Access Compliance Report

Public Rights-of-Way

(Curb Ramps)

Intersection ID: 2765	Main Street: BEAUVISTA_DR	Cross Street: HICKORY_COVE_LN	Location: SE
ADA ID: 99B1DC2F2B70	Ramp Type: PerpDiag	Initial Pass/Fail: Fail	Overall Compliance: No
			Severity Score: 33.75

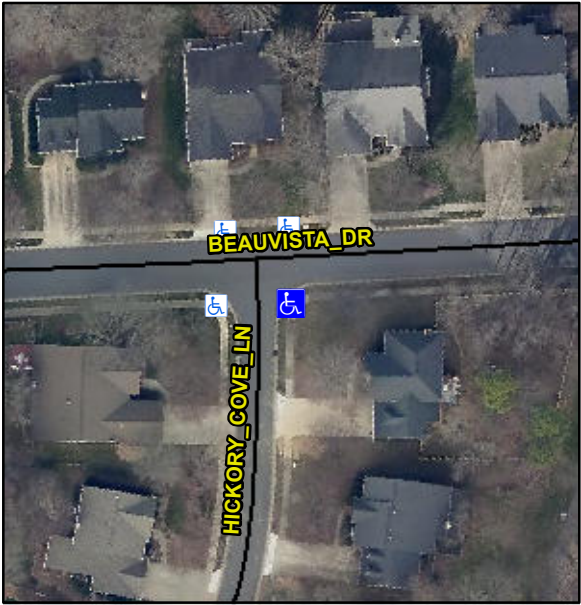
Codes/Mitigation Info/Possible Solution			Field Measurements/Component Compliance		
	Possible Solutions:		Compliance	Description	Data
	Remove & Replace Curb Ramp With Two New Directional Ramps or Equivalent.		Yes	Ramp Length (in)	5.3
			No	Ramp Width (in)	10.2
			N/A	Flare Type LT	N/A
			N/A	Flare Slope LT (%)	N/A
			N/A	Flare Traversable LT?	N/A
			N/A	Landing Length (in)	N/A
			N/A	Landing Width (in)	N/A
			N/A	Landing Slope (%)	N/A
			N/A	Landing X Slope (%)	N/A
<p>Surveyor Notes:</p> <p>N/A</p> <p>PROW/ADA:</p> <p>Not Found, R304.5.1, R304.5.3</p>			N/A	Flare Type RT	N/A
			N/A	Flare Slope RT (%)	N/A
			N/A	Flare Traversable RT?	N/A
			N/A	DWS Provided?	N/A
			N/A	DWS Contrast?	N/A
			N/A	DWS Length (in)	N/A
			N/A	DWS Full Width?	N/A
			N/A	DWS Offset (in)	N/A
			N/A	Gutter Ponding?	N/A
			N/A	Gutter Lip Ht (in)	N/A
			No	Painted X Walk1?	No
				X Walk 1 Direction	To N
			N/A	X Walk 1 Width (in)	N/A

7.5	X Walk 1 Slope (%)	9.6
			7.8	X Walk 1 X Slope (%)	3.0
			N/A	Ramp inside XWalk1?	N/A
			8.2	Road Slope (%)	N/A
			6.0	Road X Slope (%)	N/A
			N/A	Any Obstructions?	N/A
				Obstruction Type	
Total Cost: \$ 3200.00			N/A	Storm Grate/Utility Hazard?	N/A
			N/A	Storm Grate/Utility Type	N/A
			Yes	Surface Condition? (G/P)	Good
